METROPOLITAN GOVERNMENT OF NASHVILLE AND DAVIDSON COUNTY

STAFF RECOMMENDATION
2516 Belmont Boulevard
November 20, 2019

Application: New Construction—Outbuilding; Setback Determination
District: Belmont-Hillsboro Neighborhood Conservation Zoning Overlay
Council District: 18
Base Zoning: R8
Map and Parcel Number: 11704003700
Applicant: Brad Van Rassel, Architect
Project Lead: Sean Alexander, sean.alexander@nashville.gov

2516 Belmont Boulevard, rear-right along Sweetbriar Avenue.

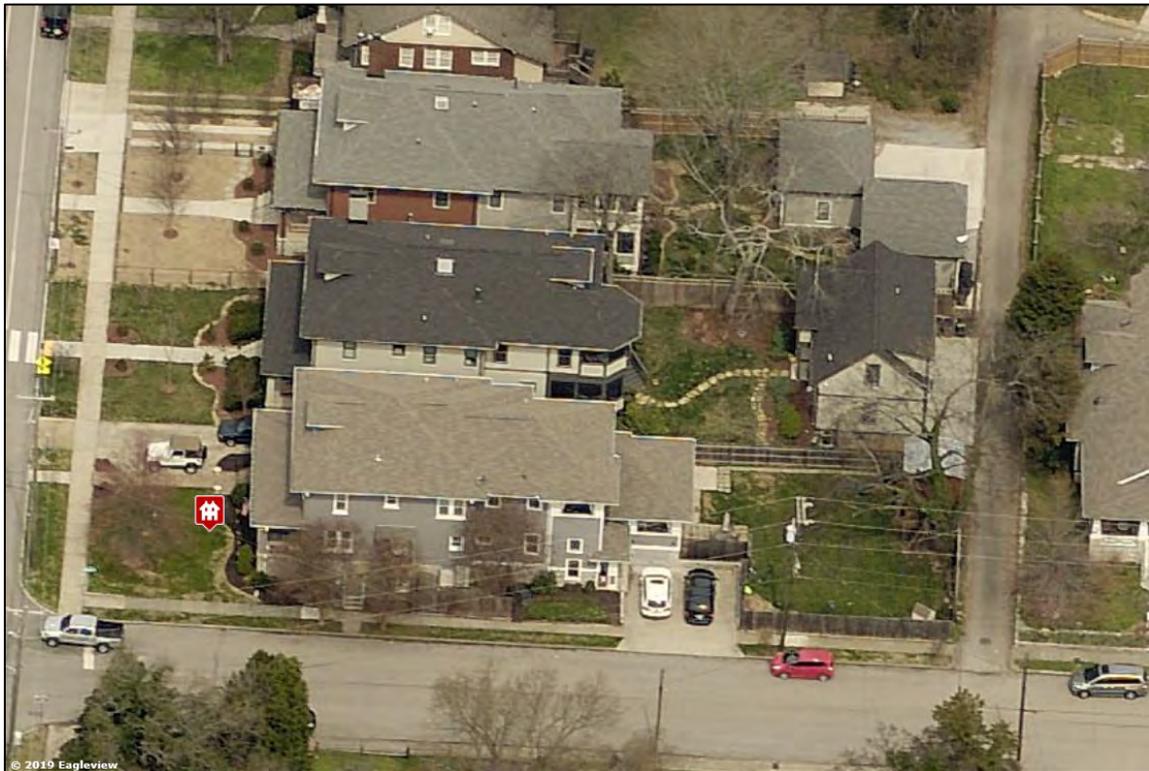
The outbuilding is proposed to be located in the rear yard, five feet (5') from the rear property line and five feet (5') from the right side property line. This rear setback meets bulk standards, but the street-side setback does not. While the MHZC does have the authority to approve reduced setbacks, the Public Works Department advised that the ten foot (10') setback on the street side of the property should be maintained to avoid creating a sight-distance issue for motorists leaving the alley; therefore, staff recommends a minimum of a ten foot (10') street-side setback.

BELMONT BOULEVARD

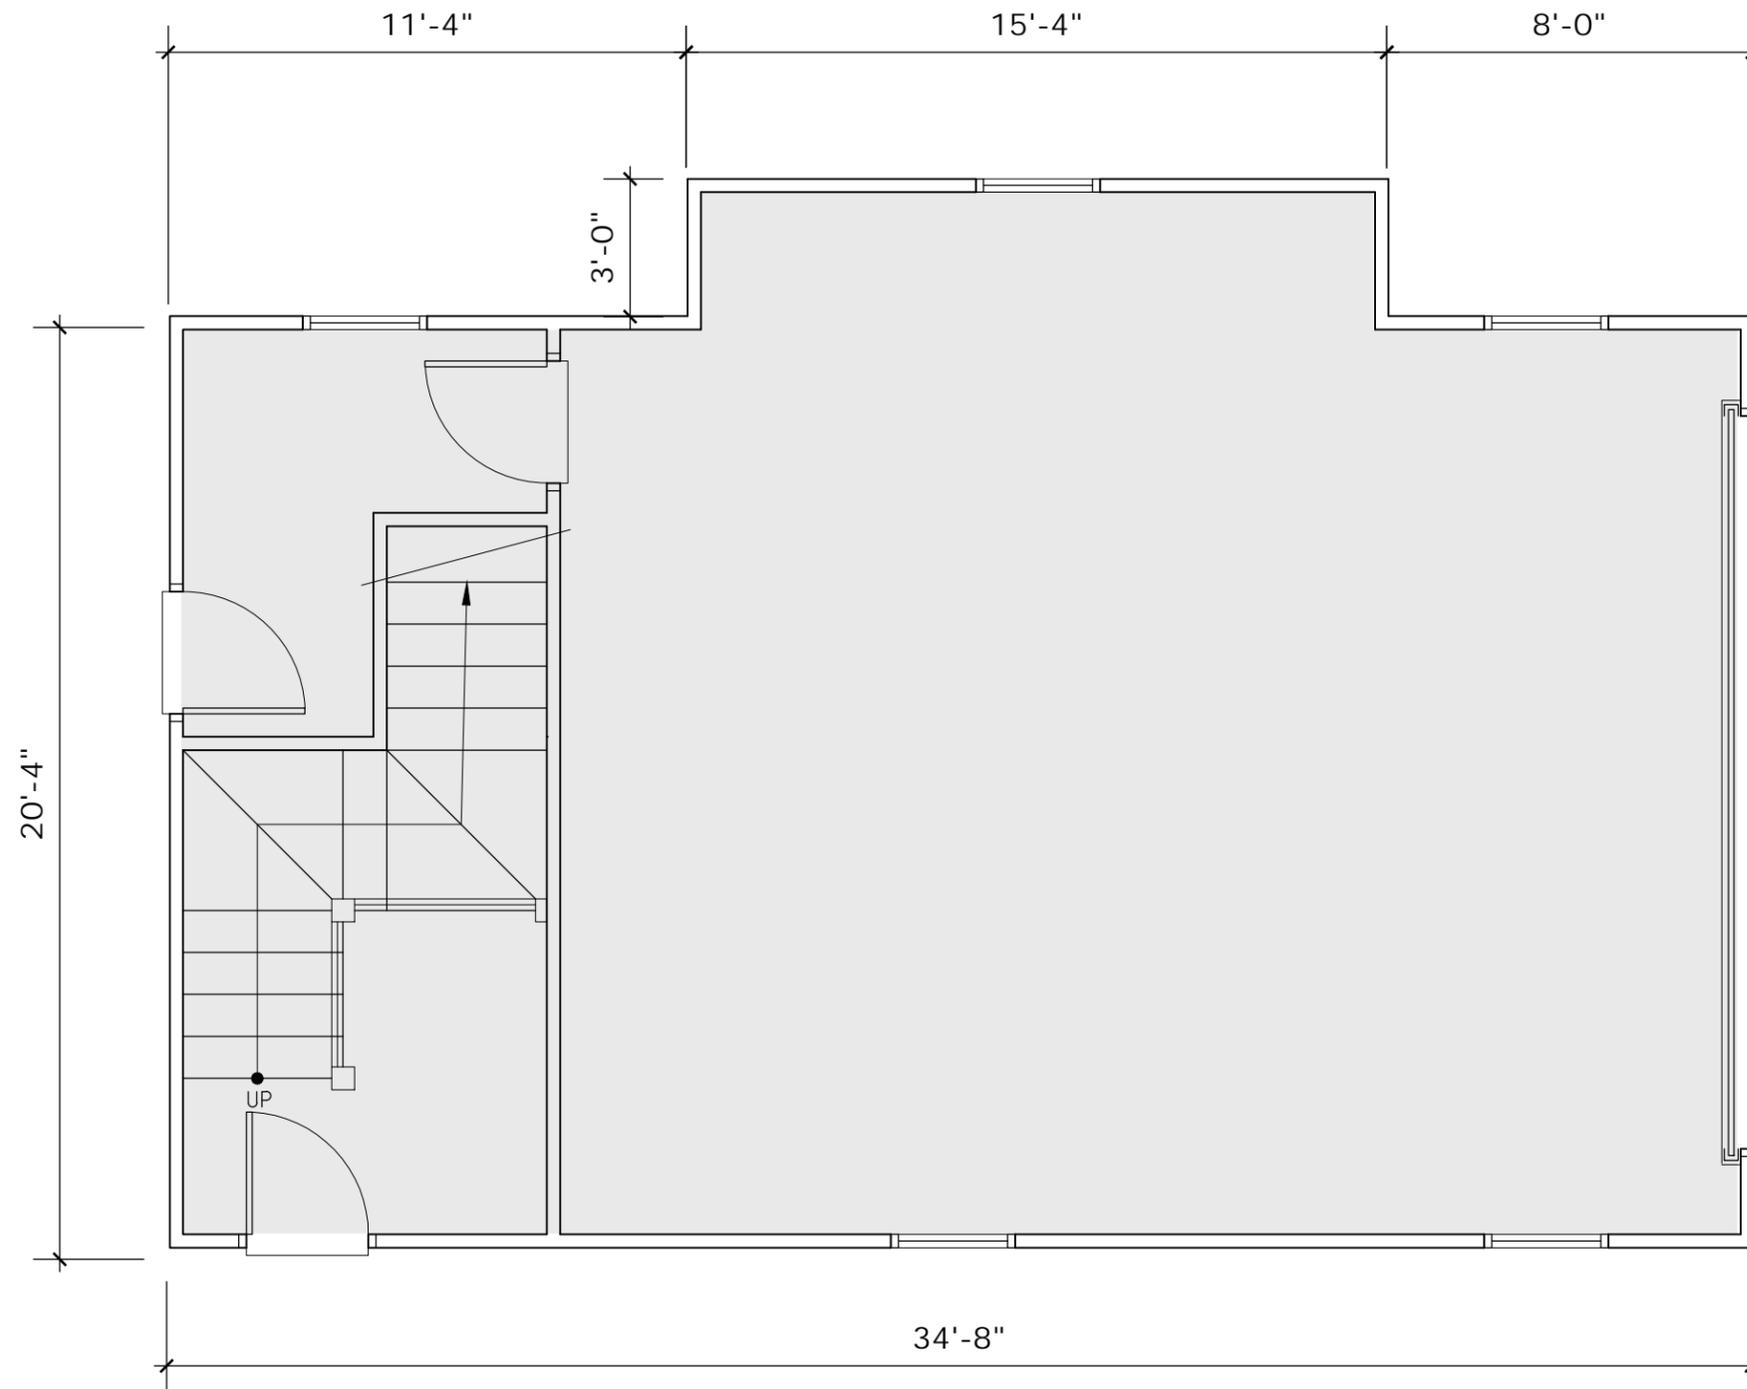
1. Staff shall approve the brick, window, and door selections prior to purchase and installation; and
2. The right side setback along Sweetbriar Avenue shall be a minimum of ten feet (10').
